## Hi-Fi Products Service Bulletin

**Model:** ST-818M/-H300/-H500

**No. 188**

**Subject:** Beat Noise On Tuner

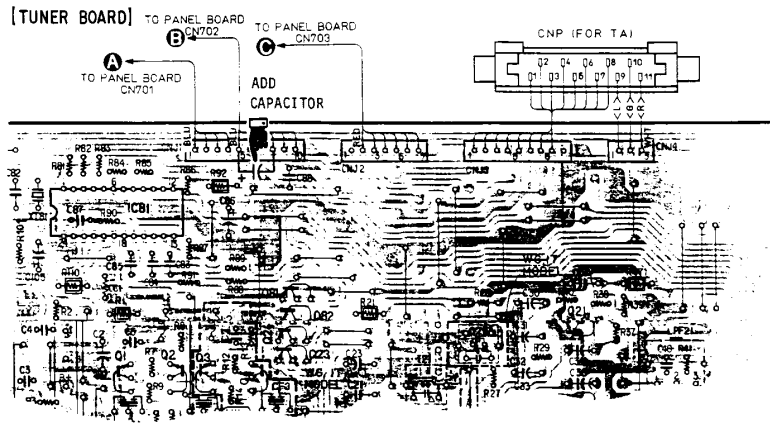
**Symptom:**  
(54)

When listening to the system at a low level, background noise can be heard.

**Solution:** The problem is due to insufficient ground. To solve this problem, (remove C89 if present in the unit) and place a 100uf 10v capacitor across pins 5(+) and 8(-) of connector CNJ1.

Description	Part Number
100uf, 10V Capacitor	1-124-443-00
